## 6:1 DOWNHAUL

## NEW RULES APRIL 2005

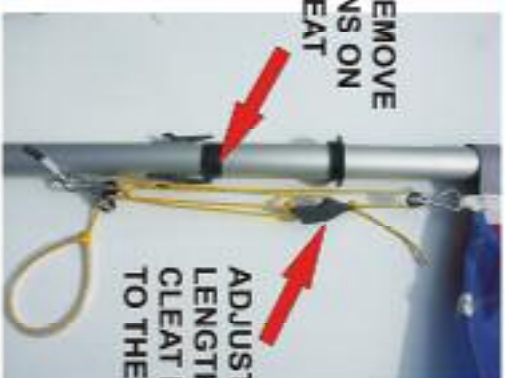
TAPE OR REMOVE THE HORNS ON THE CLEAT

ADJUST ROPE LENGTHS SO CLEAT IS TIGHT TO THE BOOM

The simple cleat on the aft face of the mast may have to be removed and blanked off with aluminium rivets or the 'horns' could be trimmed back

- USE 750mm OF 3mm ROPE and a 4mm BOBBLE
- SMOOTH THE EDGES OF THE TOP MAST CRANE
- TURN THE CRANE TO FACE FORWARD
- DRILL A 5mm HOLE IN THE BOBBLE
- FEED A LOOP OF ROPE THROUGH THE BOBBLE
- TIE THE SAIL AS SHOWN
- TENSION THE ROPE BY PULLING OVER THE FRANGES AS IN DIAGRAMS 6&7
